CITY OF SOUTHGATE PLANNING COMMISSION AGENDA

1. Site Plan Review, 12790 Reeck
2. 11155 Allen PUD Approval Extension Recommendation

Site Plan Review

ACTION REQUESTED: Site Plan Review

ISSUED FOR	DATE
SPA	08/18/2025
DATE:	
DRAWN: ACA	
CHECKED: ACA	
SCALE: 1"=30'	
JOB NO: TE-25-152	
SHEET TITLE:	
SITE LAYOUT AND PAVING PLAN	
SHEET	
C3.0

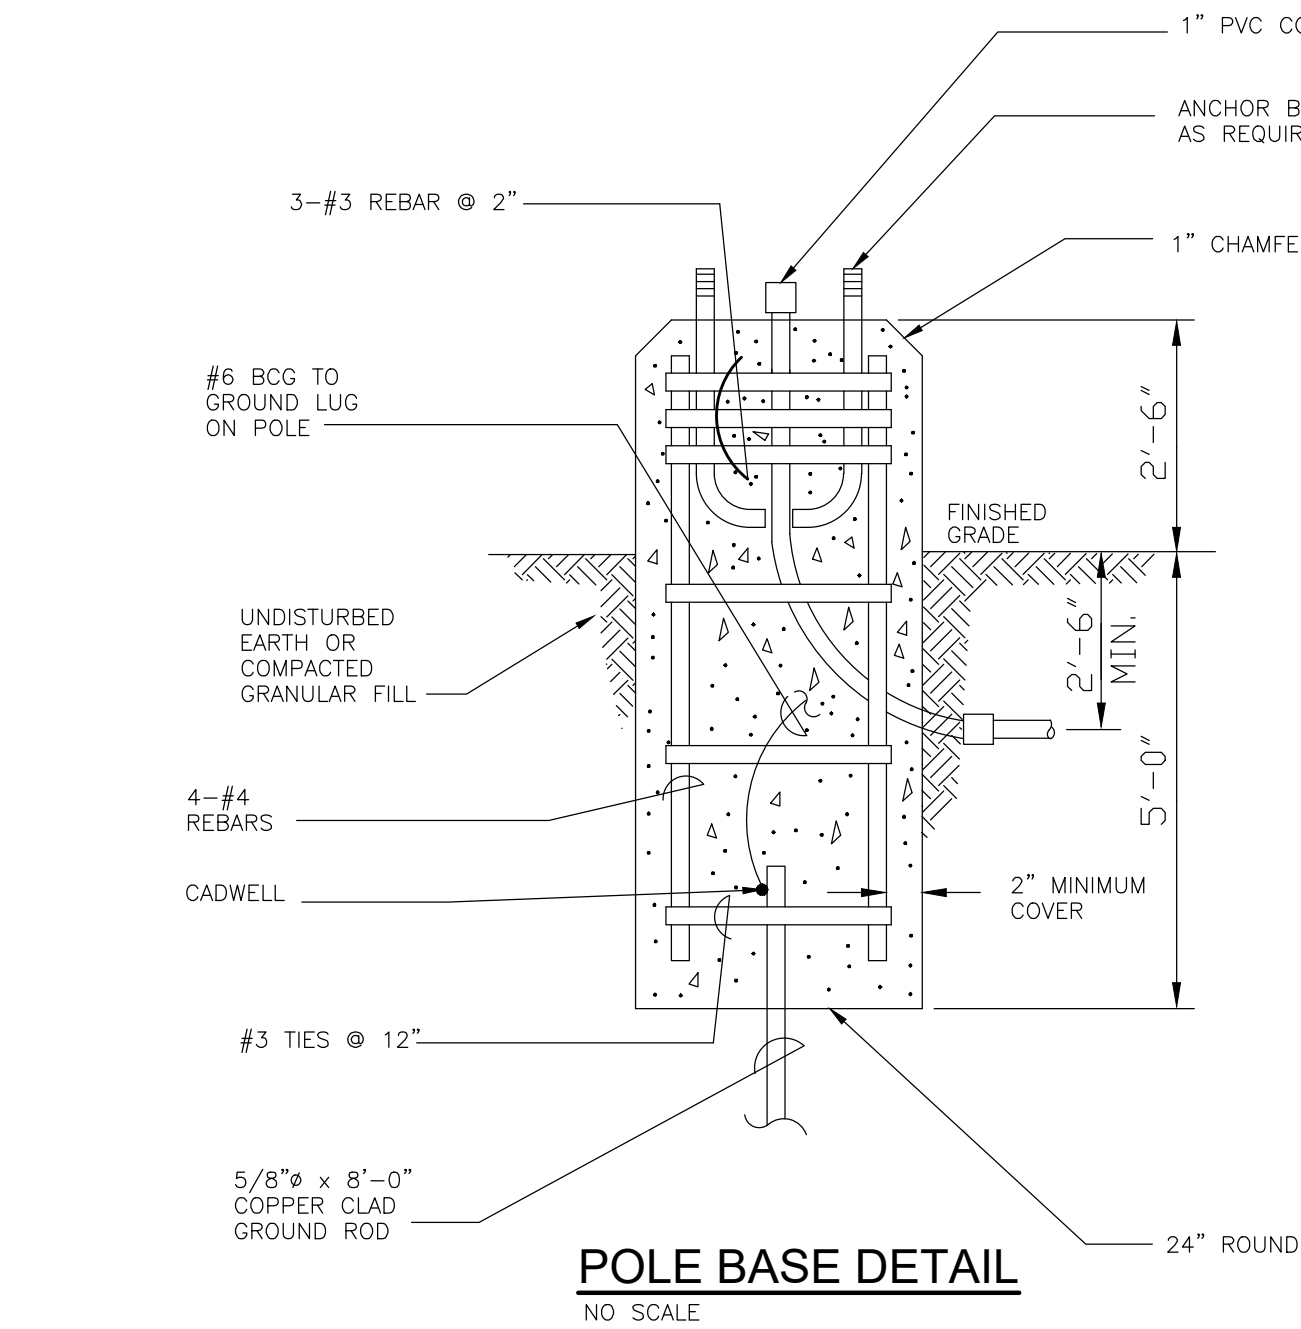
Section 1292.03 requires maneuvering lane width for 90-degree parking to measure at least twenty-two (22) feet. Current plan shows and exceeds this measurement, showing maneuvering lane widths of twenty-four (24) feet. Parking space dimensions require minimum of ten (10) feet by nineteen (19) feet, to which proposed dimensions show 9x19 feet. The width of all parking spaces will need to be increased to ten (10) feet, which may reduce the number of spaces proposed.

Items to be Addressed: 1) Clarify anticipated delivery activities. 2) Increase parking space width to ten (10) feet.

ISSUED FOR	DATE
SPA	08/18/2025
DRAWN: ACA	
CHECKED: ACA	
SCALE: 1"=30'	
JOB NO: TE-25-152	
SHEET TITLE: LANDSCAPE PLAN	
SHEET	
L1.0

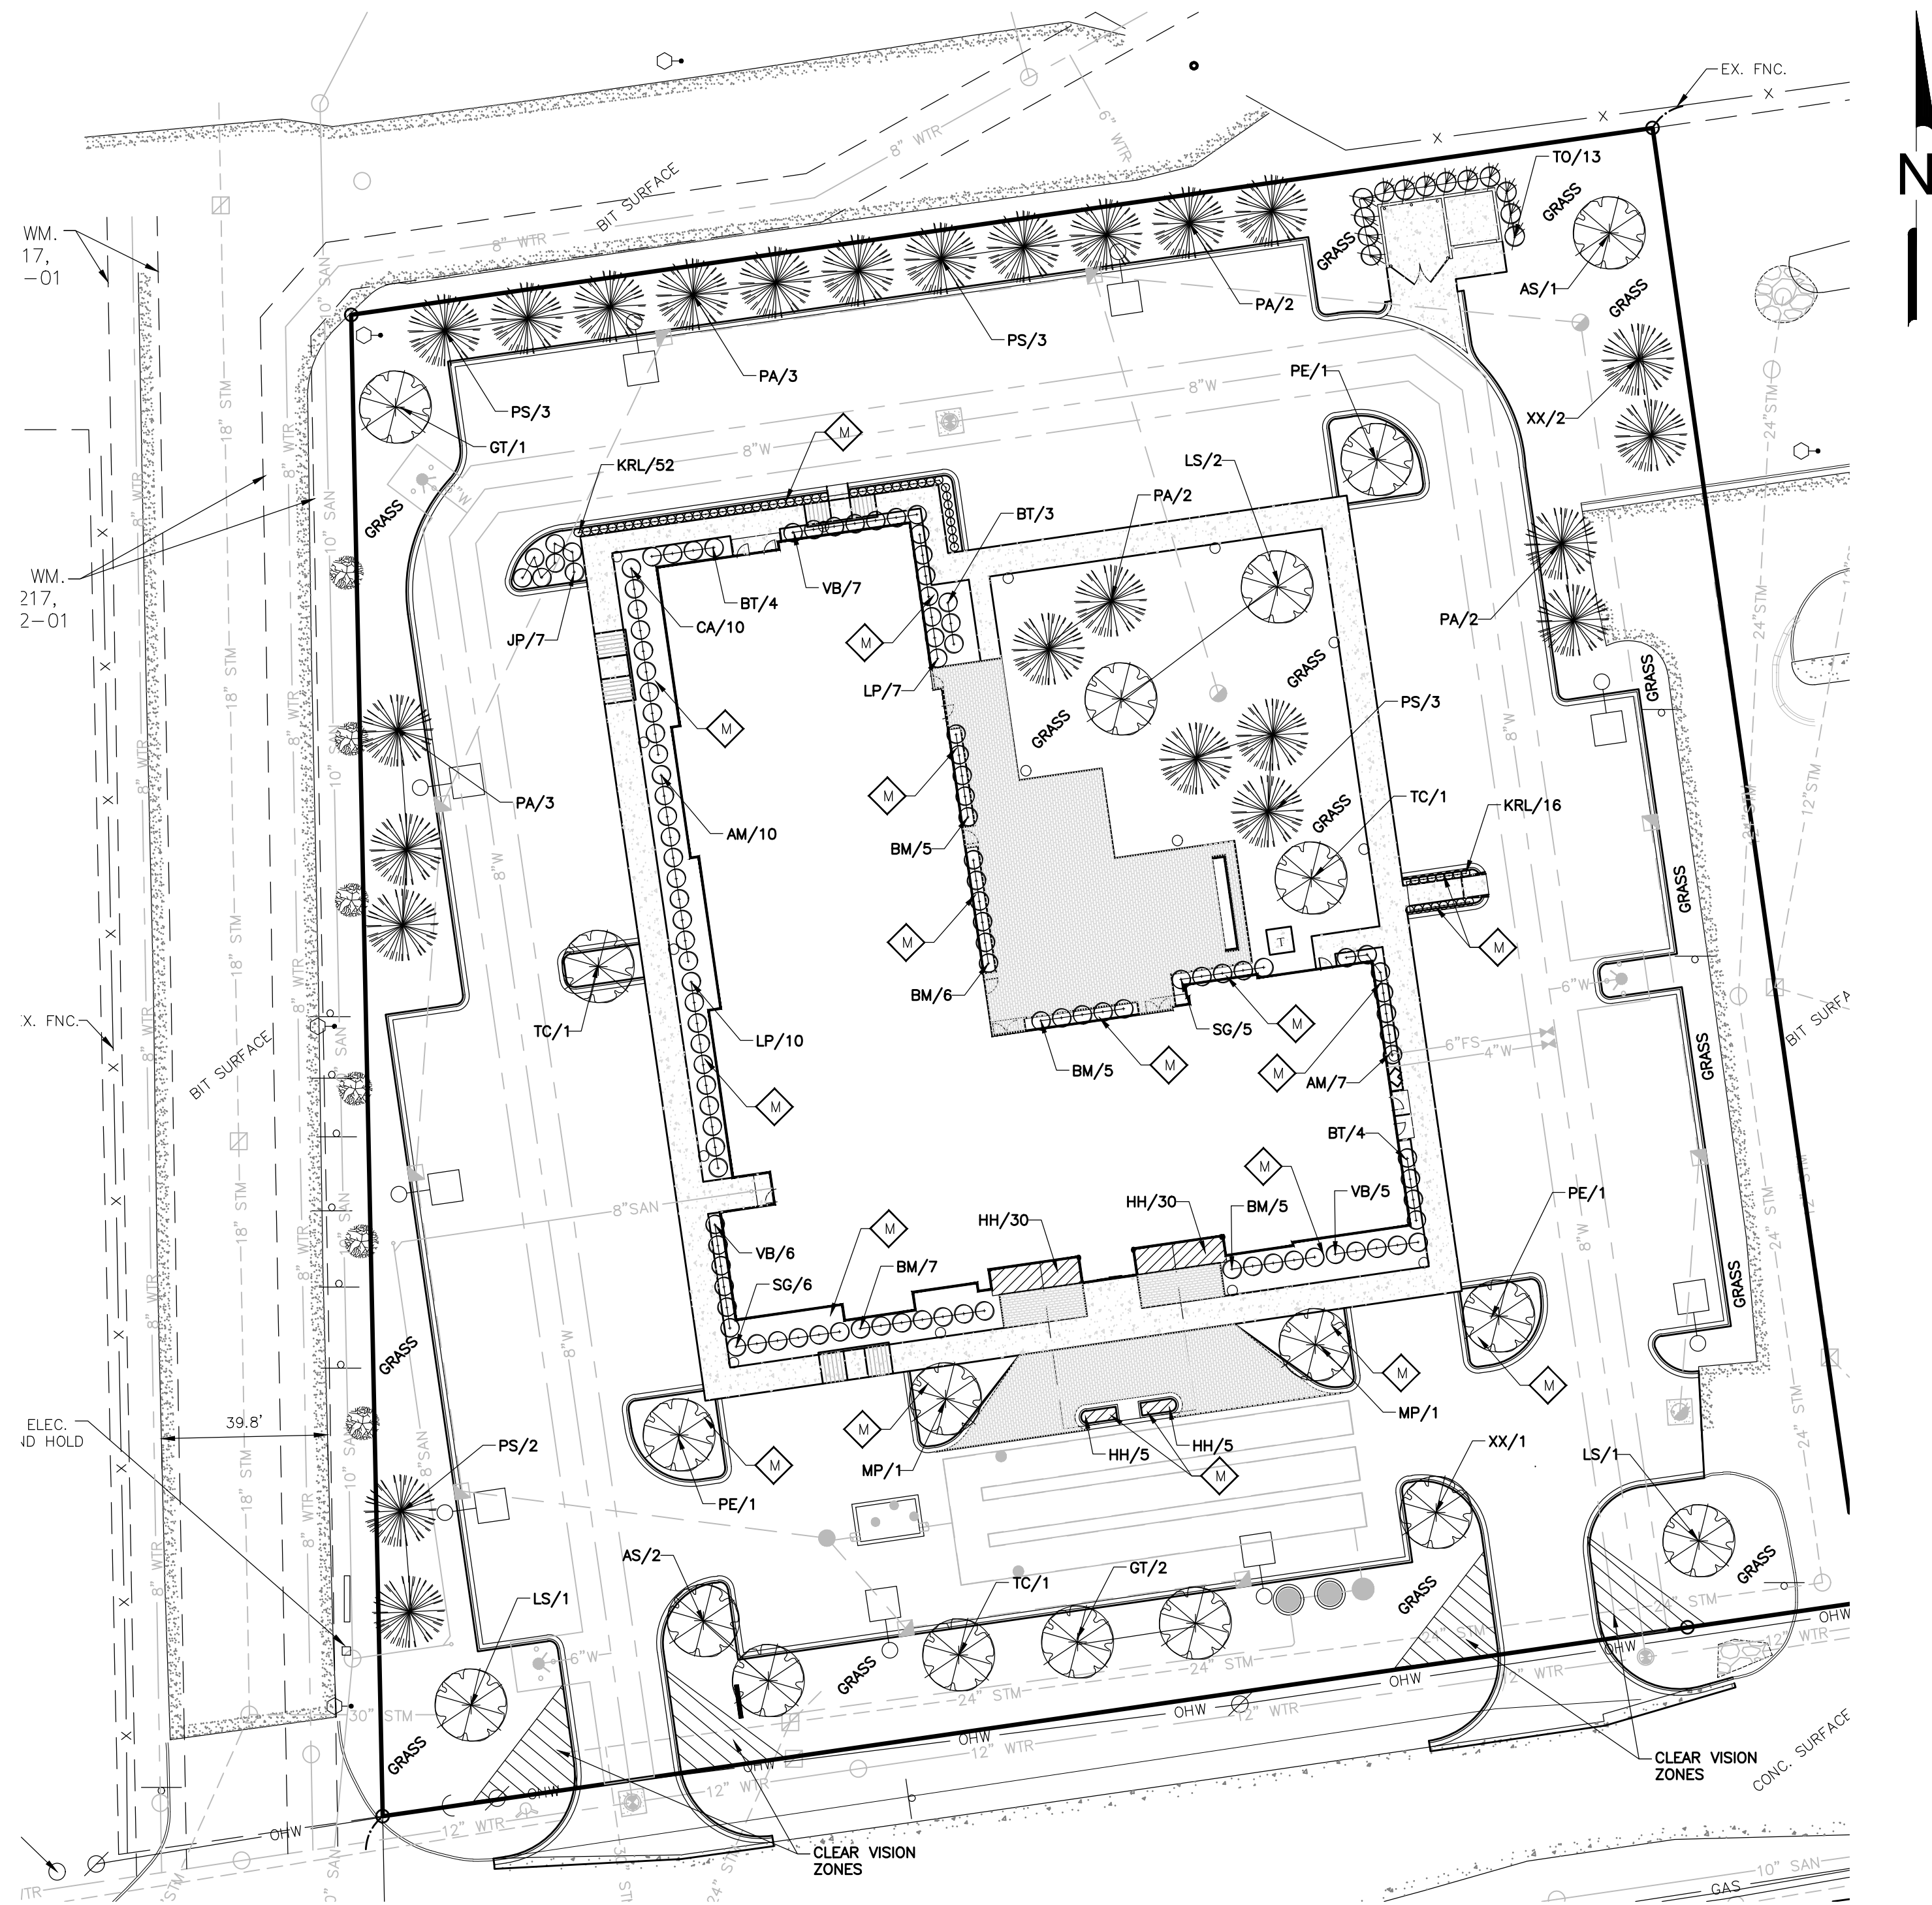
A landscape plan has been provided on sheet L1.0.

Street Trees: Eight (8) deciduous trees are proposed along Reeck Road on the southern portion of the site. All proposed plantings are required to meet all current American Association of Nurserymen standards, and a note confirming this requirement has been provided.

Parking Lot: Eleven (11) deciduous and twenty-five (25) evergreen trees are shown within and around the parking lot area, along with 119 shrubs of varying types and 138 perennial plantings are also shown around the site.

Section 1298.09 states *“Development which occurs in a nonresidential district shall provide, in addition to any existing or proposed street right of way, at least ten percent of the net site area (exclusive of buildings, off-street parking areas, etc.) as landscaped open space.”* Current plans show a calculation of 30%, meeting ordinance requirements.

Per section 1298.09, a landscape plan shall also consist of planting cross-section details, as well as planting size and spacing dimensions, all of which are provided on the current landscape plan. Plan notes also indicate the site will be properly irrigated. The applicant shall also provide the City with a landscape guarantee covering the cost estimate of all new plantings.

Items to be Addressed: *Provide landscape guarantee to City.*
